# DART SERVICE INSTRUCTION

TO AMEND INSTALLATION INSTRUCTIONS IIN-D212-664 Rev. G OR LATER  
& INSTRUCTIONS FOR CONTINUOUS AIRWORTHINESS ICA-D212-664 Rev. 8 OR LATER  
REF. CANADIAN STC: SH01-9  
REF. FAA STC: SR01298NY  
REF. EASA STC: EASA.IM.R.S.01304

A	NEW ISSUE	CP	13.12.19
REV.	DESCRIPTION	BY	DATE
DESIGN	q	<b>DART AEROSPACE LTD</b> HAWKESBURY, ONTARIO, CANADA	
DRAWN	q		
CHECKED	ASS	DRAWING NO.	REV. A
MFG. APPR.		DSI 9680	SHEET 1 OF 3
APPROVED		TITLE	SCALE
DE APPR.		SUPPORT INSTALLATION ON 214 A/C	NTS
DATE	13.12.19	COPYRIGHT © 2013 BY DART AEROSPACE LTD THIS DOCUMENT IS PRIVATE AND CONFIDENTIAL AND IS SUPPLIED ON THE EXPRESS CONDITION THAT IT IS NOT TO BE USED FOR ANY PURPOSE OR COPIED OR COMMUNICATED TO ANY OTHER PERSON WITHOUT WRITTEN PERMISSION FROM DART AEROSPACE LTD.

**FIGURE 1:**  
**SUPPORT INSTALLATION ON 214 AIRCRAFT**

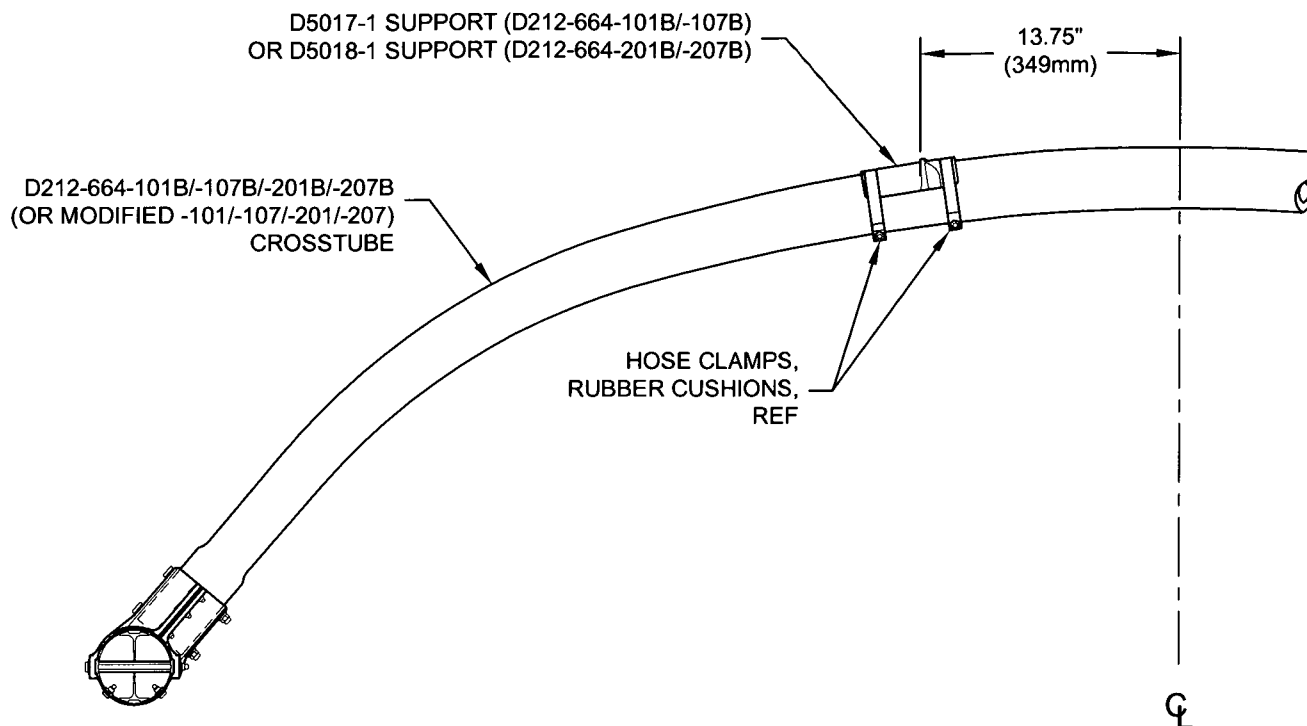
When installed on 214 aircraft, the hose clamps on D212-664-101/101B/-107B/-201B/-207B crosstubes interfere with the aircraft's cap assemblies. The affected crosstubes are D212-664-101/-101B/-201/-201B at CHG 005 and earlier, D212-664-107/-107B at CHG 003 and earlier, and D212-664-207/-207B at CHG 002 and earlier. There is no interference when installed on 204/205/210/212/412 series aircraft.

For crosstubes on 214 aircraft, the existing D2893-1 & D2940-1 crosstube supports should be replaced with the new D5017-1 & D5018-1 supports per ICA-D212-664 (section 32.3 and 32.4 of rev. 8 or later revision) using a 13.75" spacing. See Figure 1 of this service instruction for reference.

The DSI 9680-011 Support Kit is available from Dart and contains new supports for crosstubes installed on 214 aircraft. The kit can be installed on existing D212-664-101/-101B/-107/-107B/-201/-201B/-207/-207B to correct the interference problem with the aircraft cap assemblies. The new supports reposition the hose clamps to avoid the cap assemblies.
